Submission to Australian Human Rights Commission (AHRC)

New Generation Rollingstock (NGR) Project Queensland Government

Application for temporary exemptions under the Disability Standards for Accessible Public Transport 2002 (Cth) and Disability Discrimination Act 1992 (Cth)

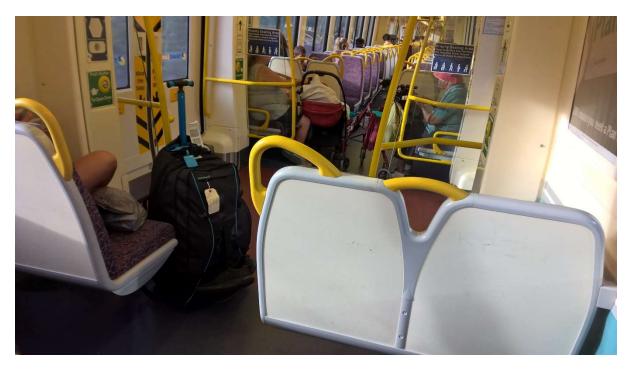
The photo (above) shows a standard entry on the NGR. Note the passenger in the seat he has shared with a large suitcase requiring his legs to occupy the corridor access space.

The photo (below) shows an older train retrofitted with some of the new seating and entry hardware again illustrating the problem with storage of objects in this case a large suitcase.
